Service Bulletin S06KV

Subject: “MICO” Low Pressure Switch Shortened Service Life

Models Affected: 2006 Model Year Blue Bird All American model buses and 2006-2007 Model Year Blue Bird Vision Model Conventional Buses Equipped With Hydraulic Brakes and Option 40051 Door Brake Interlock

FIGURE 1
(691 models)

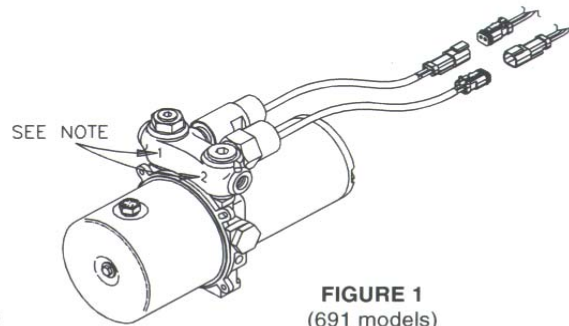
Regardless of manufacture date, the position of the high and low pressure switches have remained the same. See Figure 1, position 1 will always have a pressure switch stamped 1-800 and position 2 will always have a pressure switch stamped 2-10. Be sure to install the correct replacement switch.

1. Replace pressure switches as necessary and torque 17.6-23.1 N-m (13-17 lb-ft). **NOTE: Torque only on surface flats.**
2. **691 models:** Reattach wire connectors. See Figure 1.

FIGURE 2
(earlier 690 models)

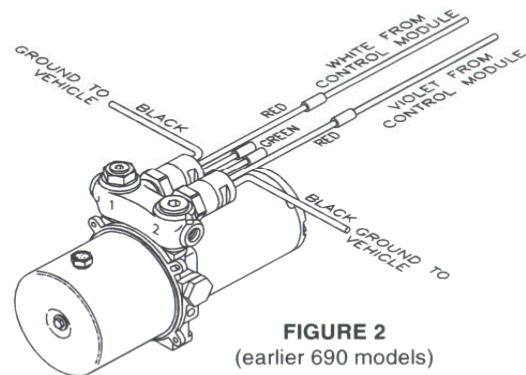
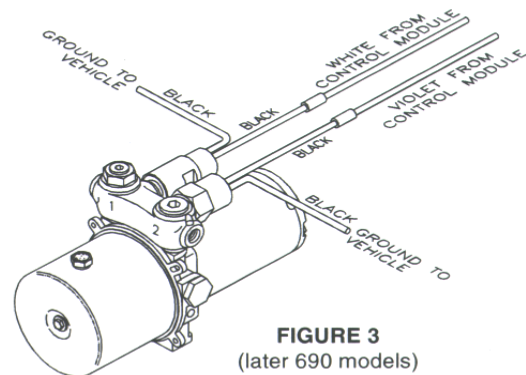
3. **690 models:** Earlier models of the 690 power unit provided a black wire, red wire, and green wire from each of the pressure switches as shown in Figure 2. These style switches are no longer available. Later models use pressure switches which provide two black wires from each as shown in Figure 3. When replacing pressure switches, either one of the black wires from each pressure switch can be used to connect to ground. Connect the other black wire from the pressure switches to the white wire or violet wire as shown in Figure 3. The pressure switch that connects to the white wire is stamped 1-800. The pressure switch that connects to the violet wire is stamped 2-10. **NOTE: Replacement switches may have connectors similar to FIGURE 1. Remove connectors as needed.**
